# febi 187940

Engine: EA111 1.2 TSI

## Turbocharger

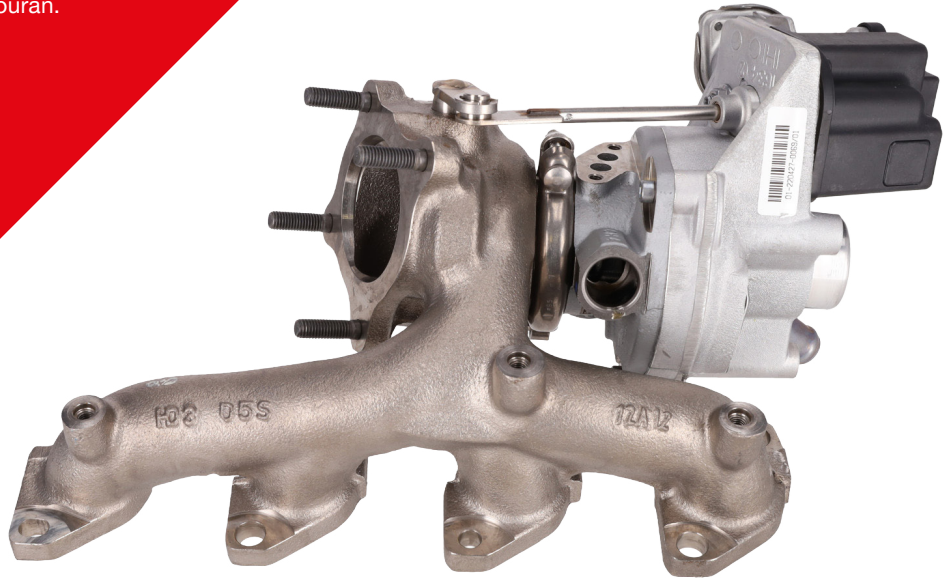
Engine has no power. Turbocharger actuator error and incorrect voltage values after replacement of the turbocharger.

Three different turbochargers were used during the production period of the 1.2 TSI EA111 engine. However, they are not interchangeable with each other. Differences in engine control unit software versions and/or lengths of the actuator linkage can cause the symptoms listed above.

The issue originated from the actuator rod being mounted directly above the exhaust flap, creating an uneven load that accelerated flap shaft wear and caused the exhaust flap to jam.

The first modification from the vehicle manufacturer to solve this was placing washers under the actuator. This was followed by modified levers and control rods from IHI, and finally, the exhaust housing was changed again due to the introduction of a new catalytic converter design.

Compare the information on the original turbocharger's type plate before ordering a replacement turbocharger - this is vitally important to ensure correct fitment and operation.

After reinstalling the new turbocharger - if it is identical to the original - reconnect the battery, switch the ignition on, wait 10 seconds, then switch it off again. Repeat this process 10 times.

Carry out a 'capacitor reset'. Disconnect the battery for at least two hours, preferably overnight, and then hold the + and - terminals together to discharge the residual voltage of the capacitors. This will reset all learning values. After reconnecting the battery, switch the ignition on, wait 10 seconds, then switch it off again. Repeat this process 10 times.

Check the software version of the engine control unit. The last update from the vehicle manufacturer was from 2018, this allows for complete relearning of the actuators. Software updates can be carried out using the vehicle manufacturers' technical website and a suitable 'Pass-Thru' device, or by your local authorised Volkswagen Group workshop if required.
